Access Compliance Report

Public Rights-of-Way

(Curb Ramps)

Intersection ID: 19611	Main Street: FOXCROFT_RD	Cross Street: Warburton_RD	Location: SE
ADA ID: 61A97C3B8F9D	Ramp Type: PerpDiag	Initial Pass/Fail: Fail	Overall Compliance: No
Severity Score: 13.75			
Codes/Mitigation Info/Possible Solution		Field Measurements/Component Compliance

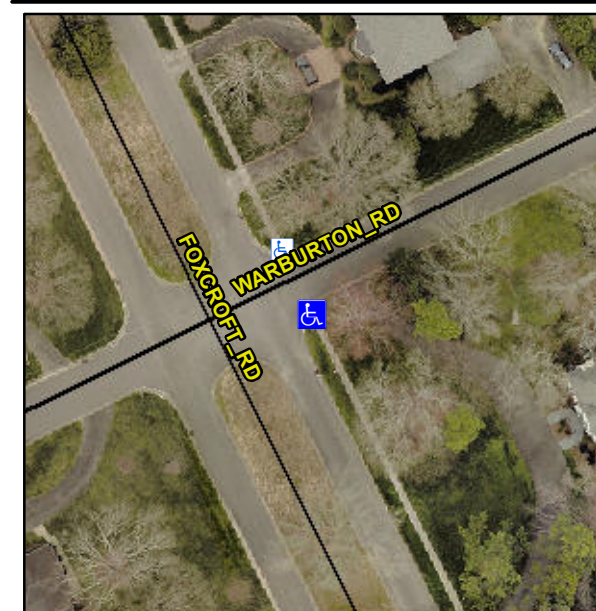
Not Found, R304.2.2, R304.5.3

Compliance	Description	Data	Compliance	Description	Data
N/A	Ramp Length (in)	58.0	No	Ramp Slope (%)	10.8
Yes	Ramp Width (in)	48.0	No	Ramp XSlope (%)	2.9
N/A	Flare Type LT	N/A	N/A	Flare Type RT	N/A
N/A	Flare Slope LT (%)	N/A	N/A	Flare Slope RT (%)	N/A
N/A	Flare Traversable LT?	N/A	N/A	Flare Traversable RT?	N/A
N/A	Landing Length (in)	N/A	N/A	DWS Provided?	N/A
N/A	Landing Width (in)	N/A	N/A	DWS Contrast?	N/A
N/A	Landing Slope (%)	N/A	N/A	DWS Length (in)	N/A
N/A	Landing X Slope (%)	N/A	N/A	DWS Full Width?	N/A
N/A	Landing Curb? (Y/N)	N/A	N/A	DWS Offset (in)	N/A
N/A	Shared Landing?	N/A			
N/A	Gutter Ponding?	N/A	N/A	Gutter Slope (%)	N/A
N/A	Gutter Lip Ht (in)	N/A	N/A	Gutter X Slope (%)	N/A
N/A	Painted X Walk1?	No	N/A	Painted X Walk2?	No
	X Walk 1 Direction	To N		X Walk 2 Direction	To SW
N/A	X Walk 1 Width (in)	N/A	N/A	X Walk 2 Width (in)	N/A
	X Walk 1 Slope (%)	0.9		X Walk 2 Slope (%)	1.9
	X Walk 1 X Slope (%)	1.8		X Walk 2 X Slope (%)	2.3

Remove & Replace Curb Ramp With Two New Directional Ramps or Equivalent.
